ADDENDUM NO. 2

PROJECT TITLE: Parker Park Community Center Pool Addition
City of Jonesboro
Jonesboro, Arkansas

COMMISSION NUMBER: 2301

DATE OF ISSUE: August 21, 2023

Commission Number 2301

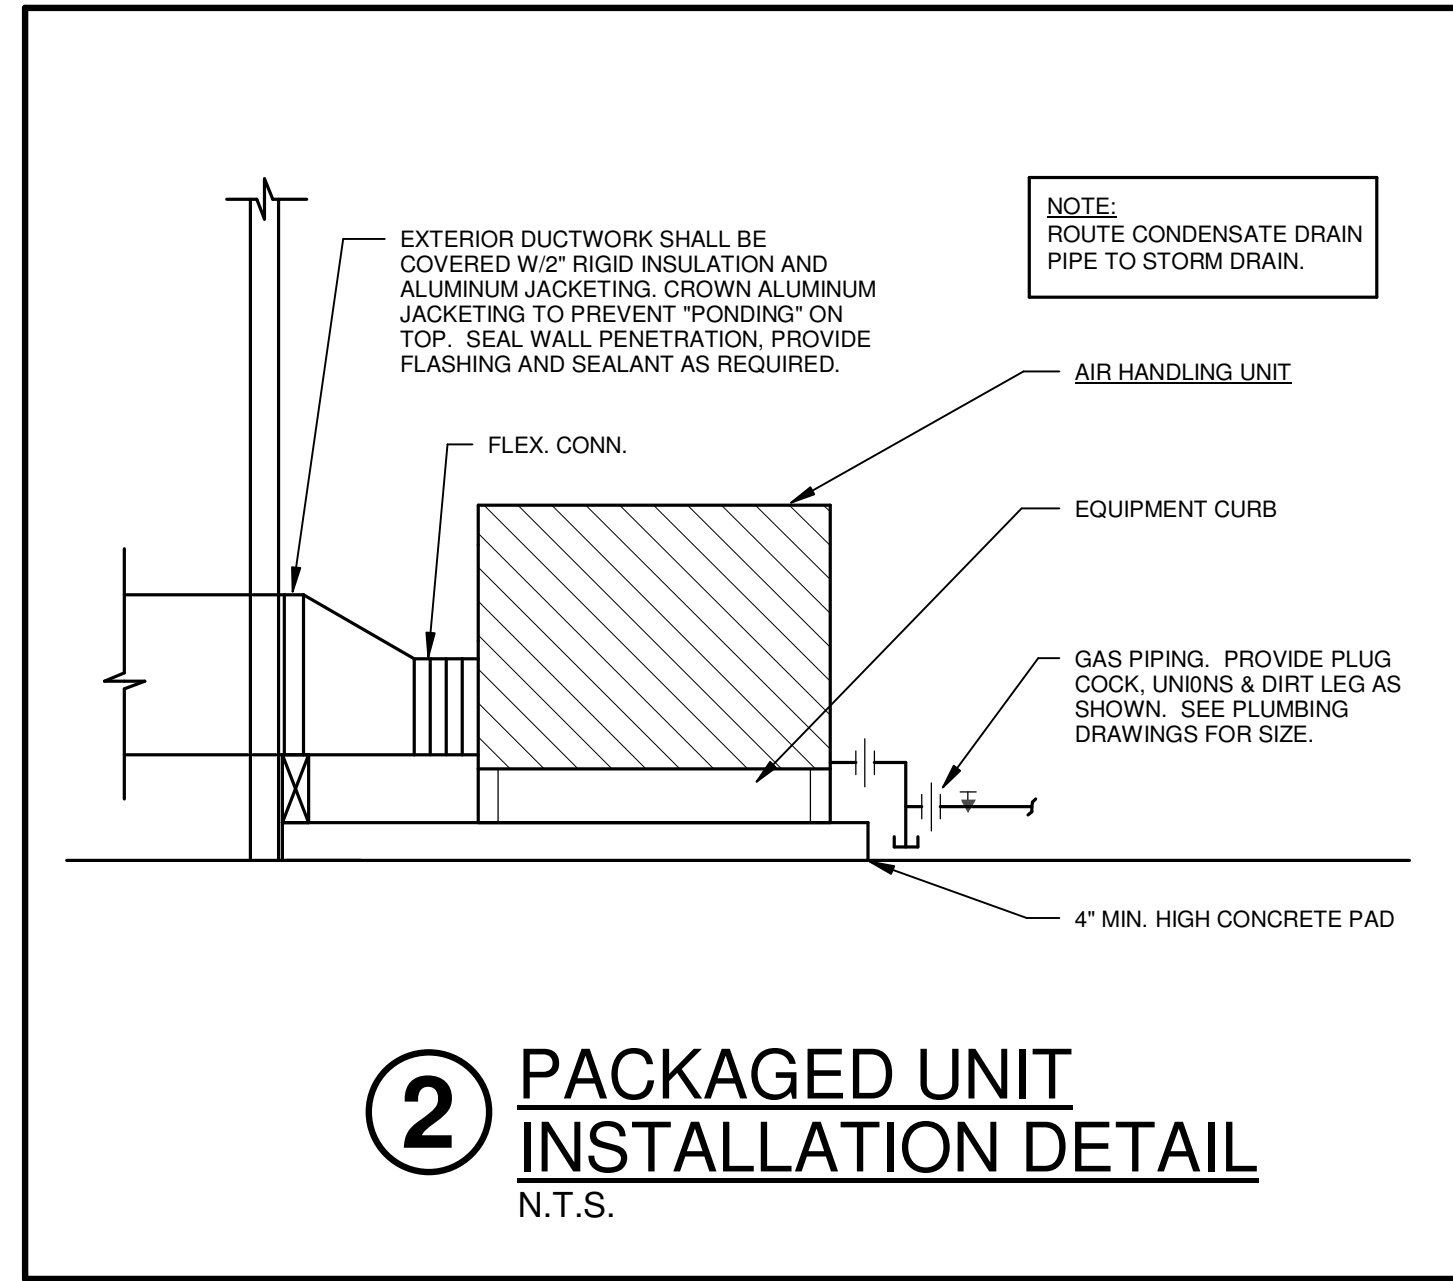
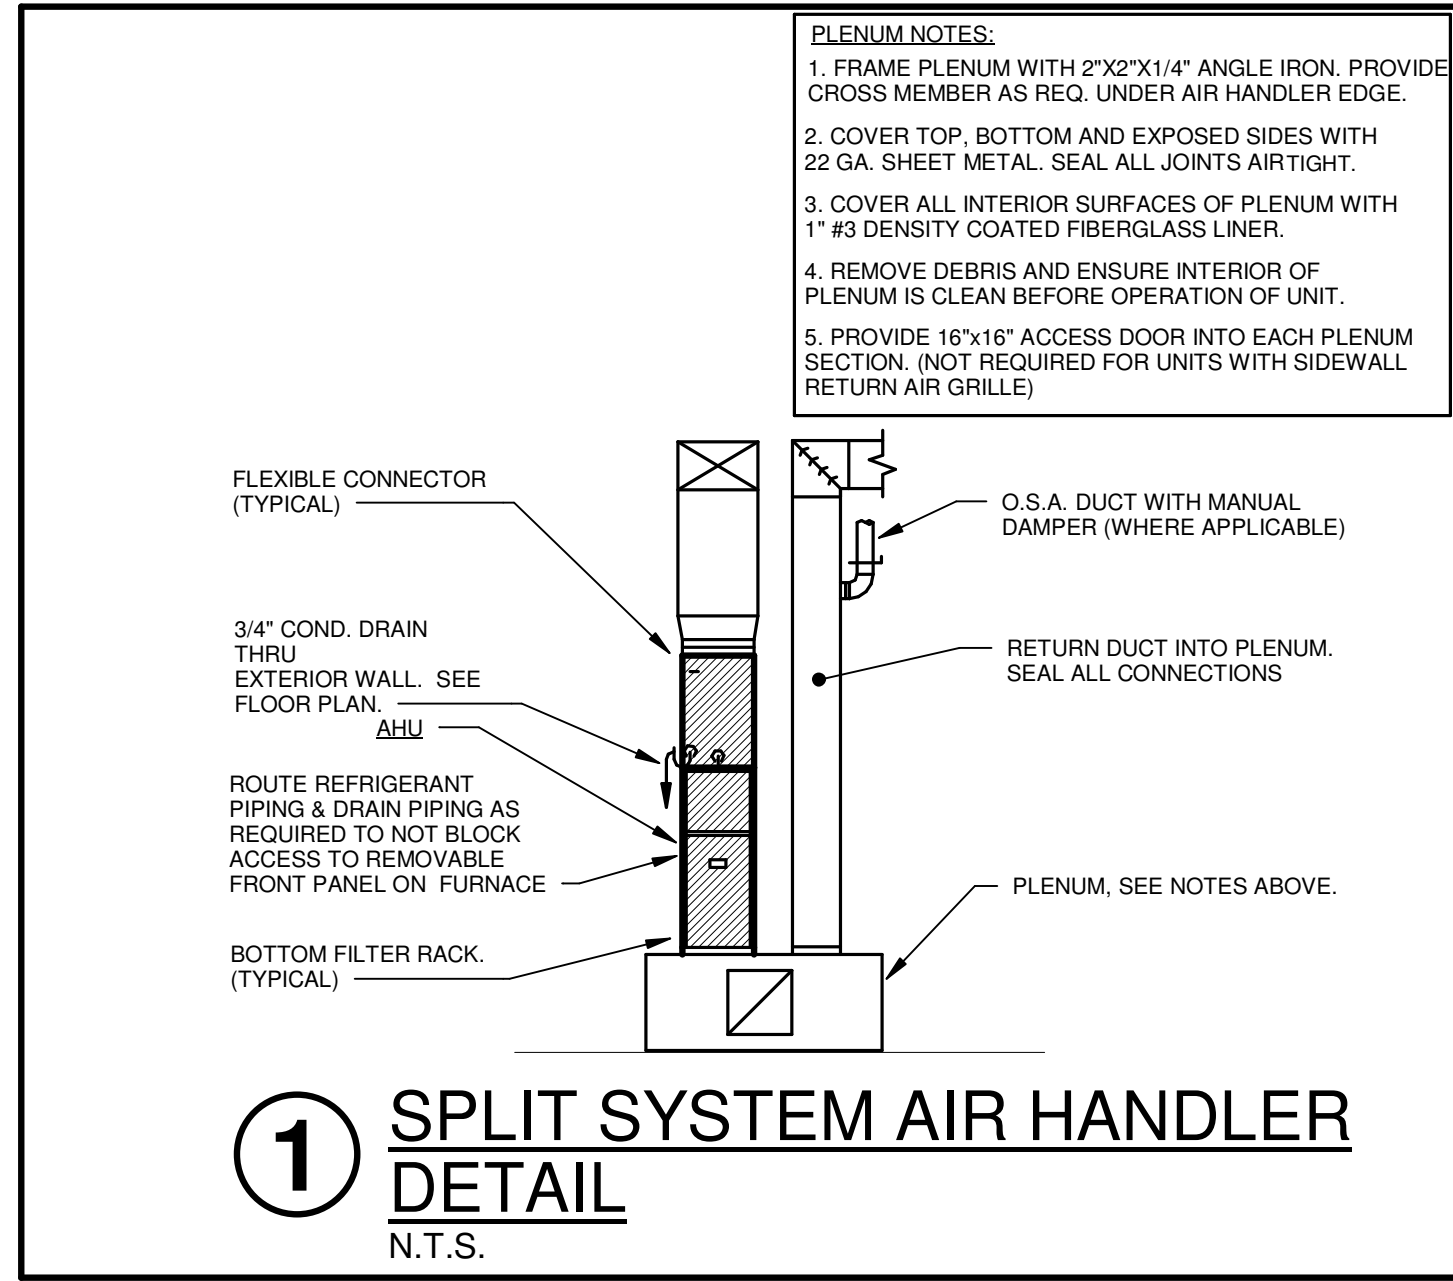
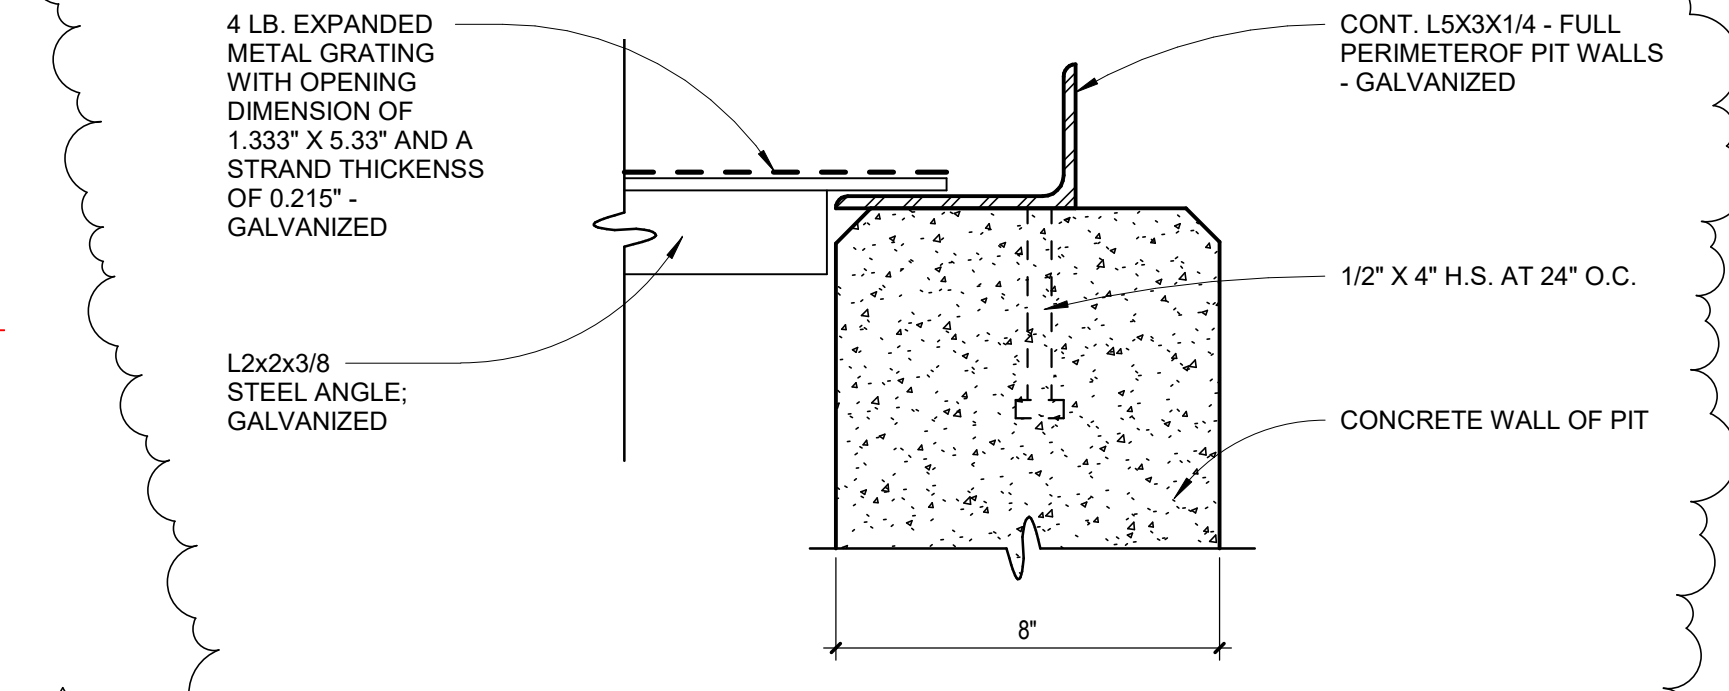
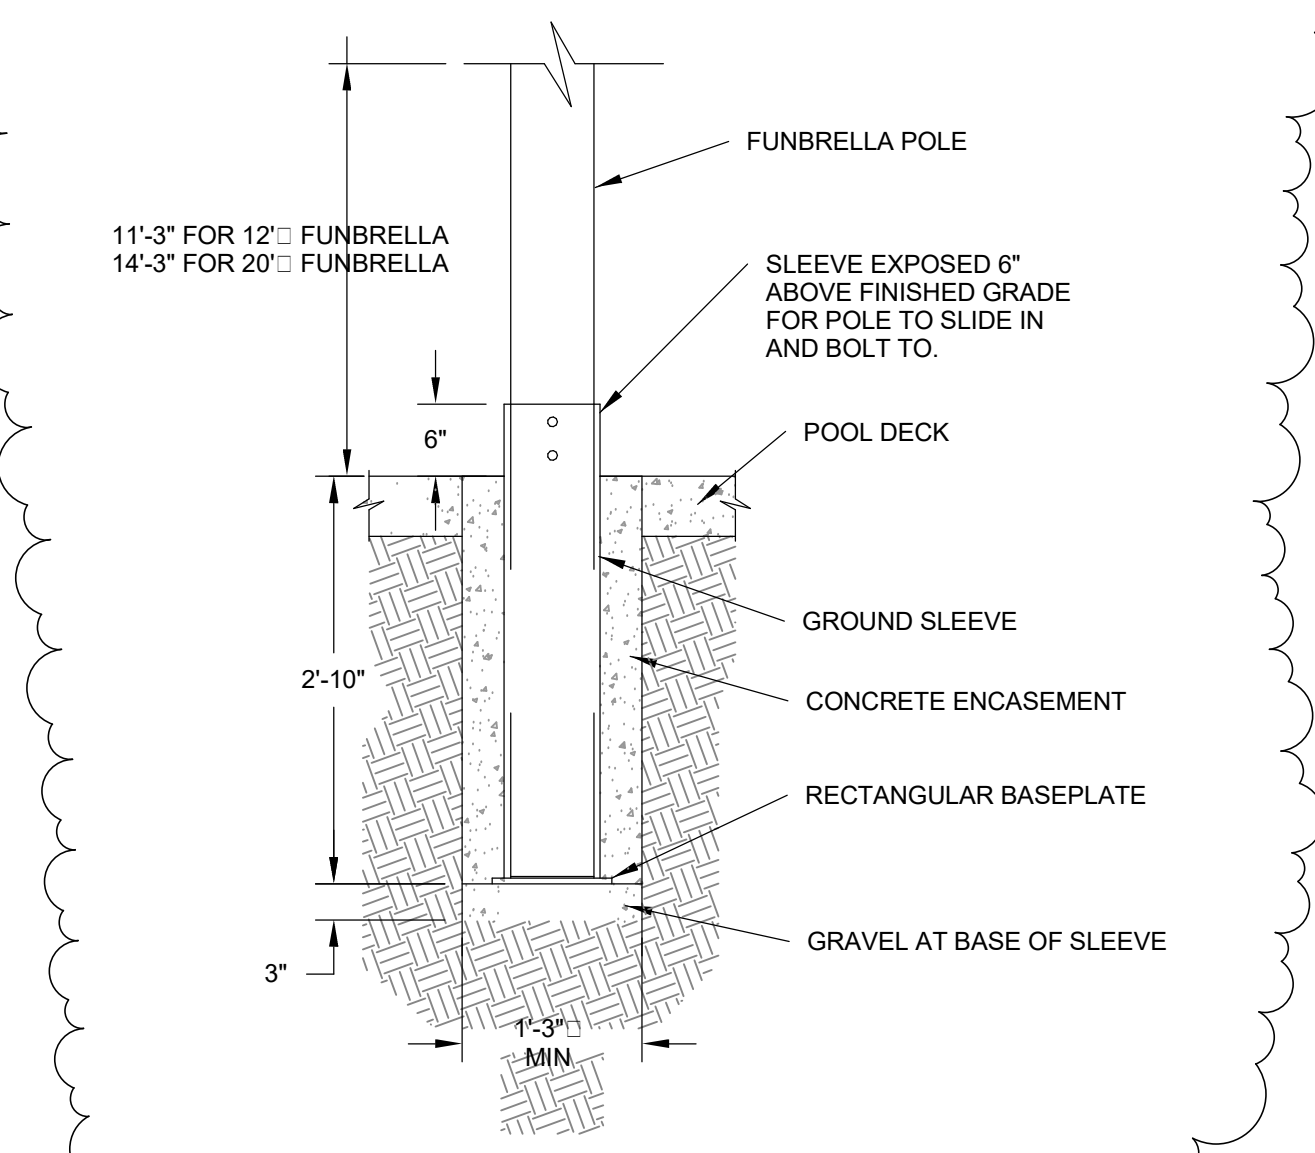
2. Drawings: Sheet C003- Enlarged Site Plan

- A. Omit Sheet C003 in its entirety. Replace with attached Sheet C003 dated 08.21.23. Refer to page 6 of this addendum.
- a. Provide self-closing (tension-adjustable) closers on all 4’-0” wide single walk gates. Design intent is for these gates to close and positively latch when entering or exiting.
 - b. Provide expanded metal covers for surge tank, pump, backwash and acid storage pits as indicated by detail 1. This will require (4) covers total matching the interior dimensions of these (4) pits. Provide min. 2 hinged access doors. All steel and expanded metal are to be galvanized.
 - c. Provide (4) additional umbrellas on patio in addition to umbrella located in the pool. See Q/A section for specifications of umbrellas and sheet C

Commission Number 2301
M402
Date: August 4, 2023

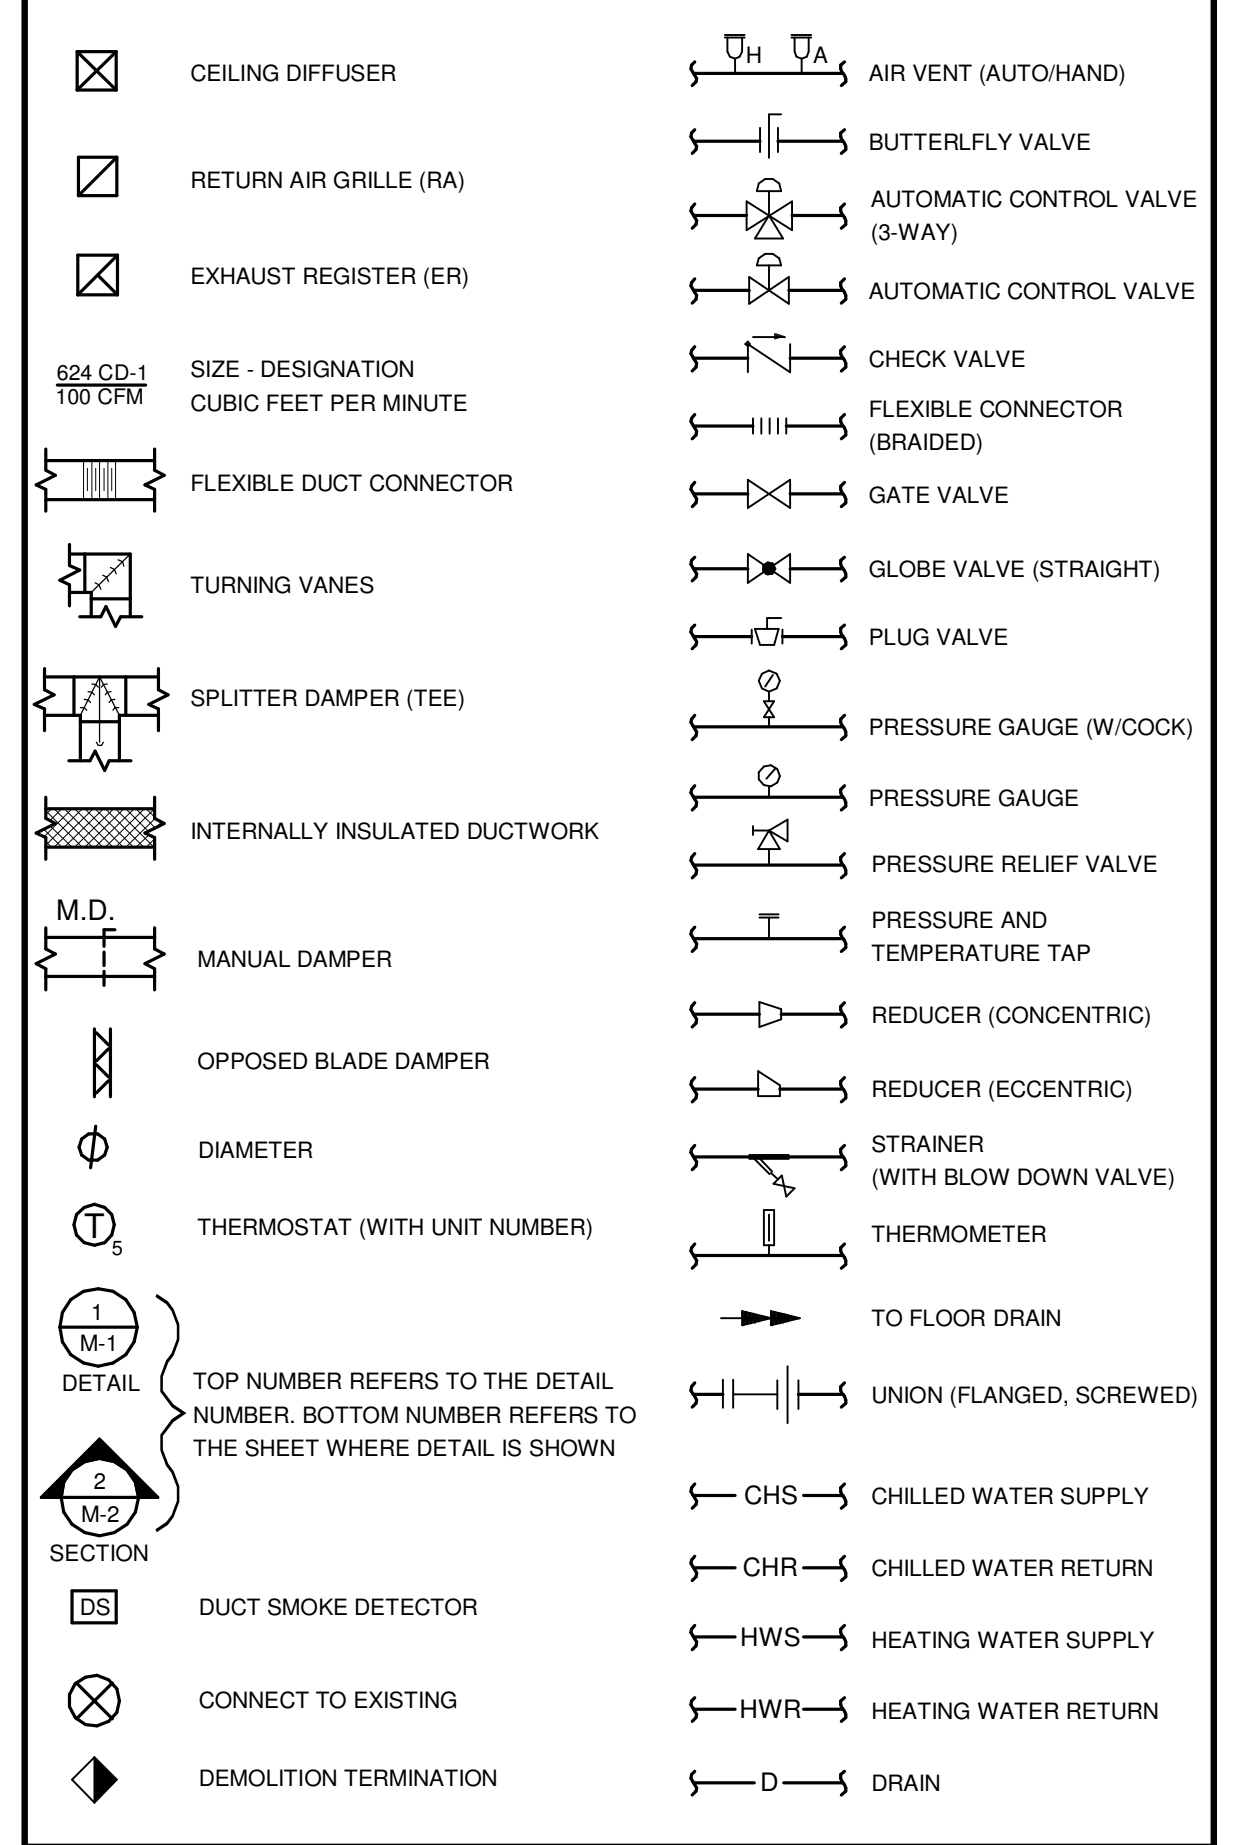
8. Drawings: Sheet M402- HVAC Schedules

- A. Omit Sheet M402 in its entirety. Replace with attached Sheet M402 dated 08.21.23. Refer to page 9 of this addendum. Revision to the exhaust fan control installation and sequence.
